AGENDA

CITY OF OPELIKA HISTORIC PRESERVATION COMMISSION

October 12, 2023

Revised rendering showing additional door.

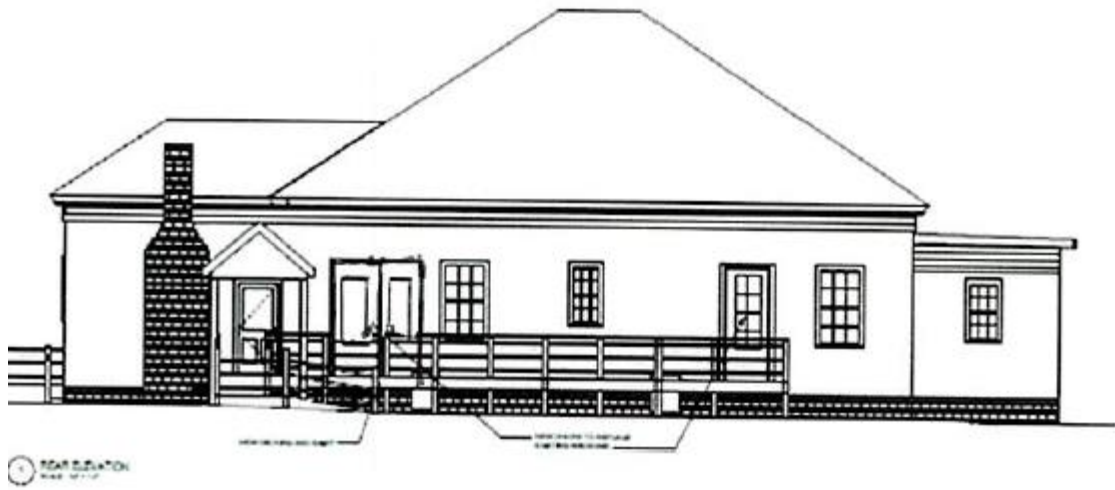
1. Approval to replace a rear window with single door was granted on 2/9/23. The applicant wishes to install a double door with full glass for better access.

Proposed deck, pergola, and steps rendering

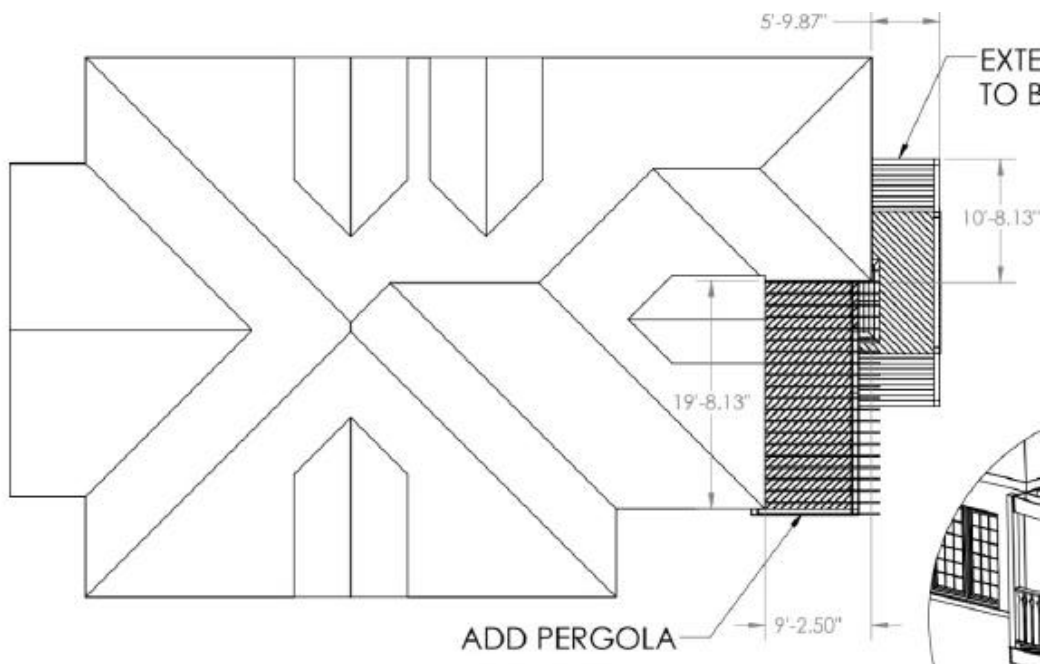
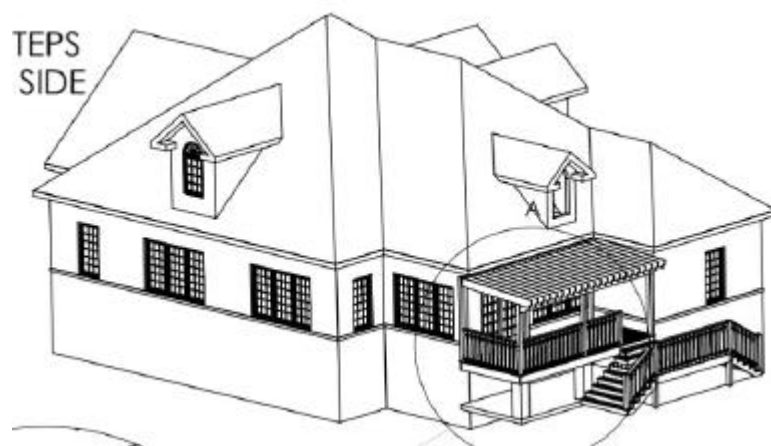
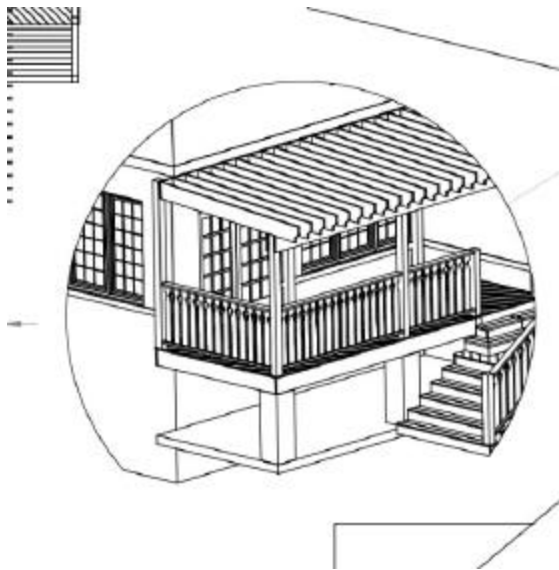
- 1. Rebuild dilapidated deck with treated lumber on back of house retaining original footprint. Add pergola and steps to side yard.

The deck is visible only from this view. The large bushes and trees block the view from other vantage points.
